TRANS/WP.29/2002/8 18 December 2001

DRAFT CORRIGENDUM 1 TO SUPPLEMENT 5 TO THE 01 SERIES OF AMENDMENTS TO REGULATION No. 6

(Direction indicators)

Annex 1, figure for categories 5 and 6, correct to read:

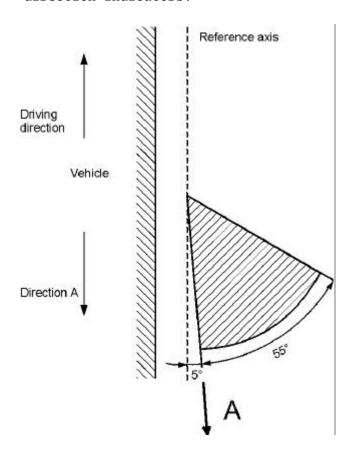
ACategories 5 and 6: Supplement side direction indicators for use on a vehicle also equipped with categories 1, 1a or 1b and 2a or 2b direction indicators.
